**FIVE DOCK, ROSEBANK COLLEGE, PROJECT 8**

**RESPONSES TO DESIGN REVIEW PANEL (DRP) REPORT AND RECOMMENDATIONS dated 20<sup>th</sup> August 2020**

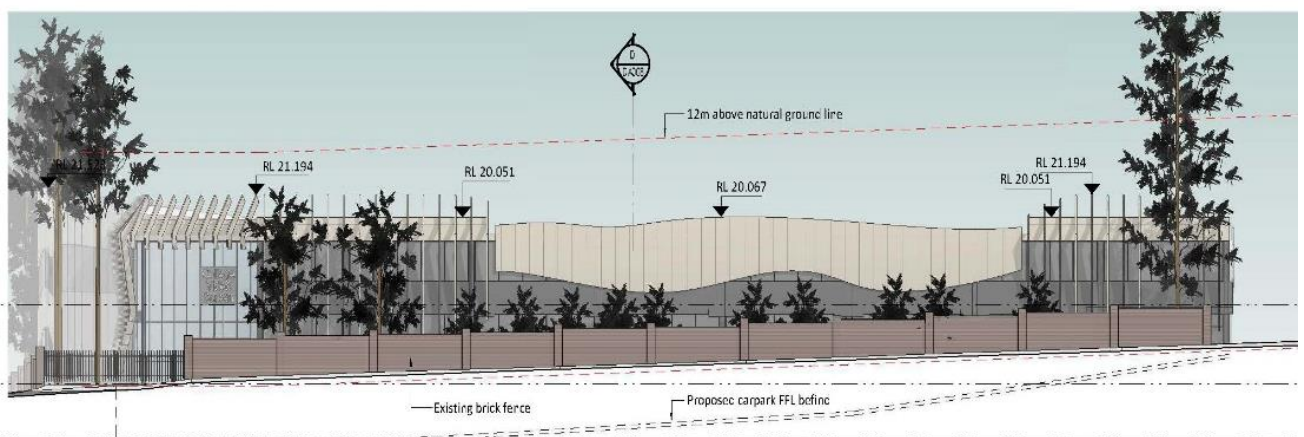
*a) The proposed carparking provision is wasteful of space and provides a poor, inactive frontage to Harris Rd.*

All frontages are in essence, *inactive*, as a result of the existing 1.8m high brick wall along all street frontages. The undercroft in the school suggested by the DRP, as the precedent for a suggested re-design at Rosebank, is very elevated with hardly any street screening and far more exposed than the proposed elevation of the new building to Harris Rd. The elevation below reveals that the carpark, as proposed, will be hardly visible from Harris Rd.

ALL HALLOWS CATHOLIC PRIMARY SCHOOL  
EDUCATION

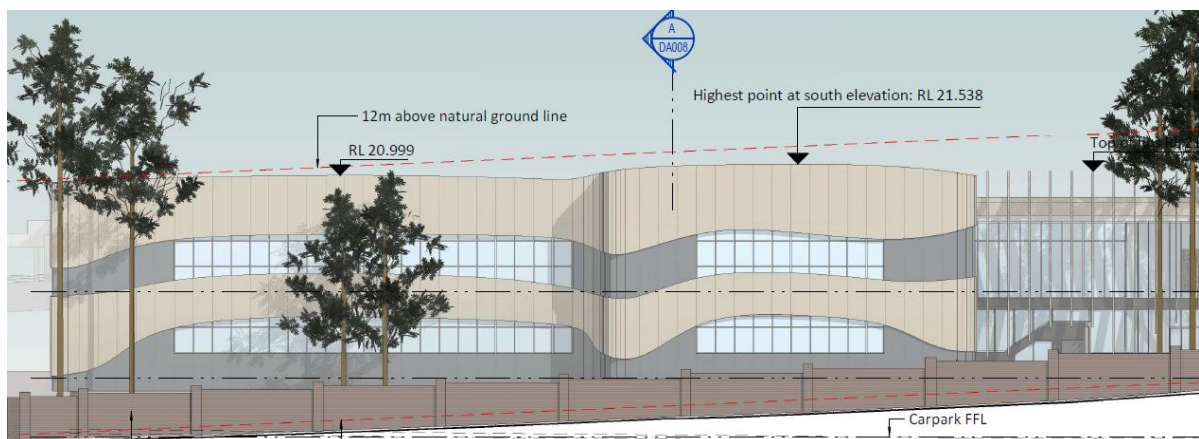
d) *The Panel is not convinced by the materiality and arbitrary pattern applied to the façade surface, as this does not effectively convey a design character readily understood as that of educational architecture. It could equally be a proposal for the façade of a commercial or light industrial building, such as already surround the site.*

This is the street façade of a recently completed, award-winning school building, clad in fibre cement, at Five Dock by BVN Architecture. Could this equally be *the façade of a commercial or light industrial building, such as already surround the site?*

It is submitted that the design concept proposed with this submission for Rosebank College is firstly, not *an arbitrary pattern of solid and void* and secondly, is a valid, site-specific contemporary design response.
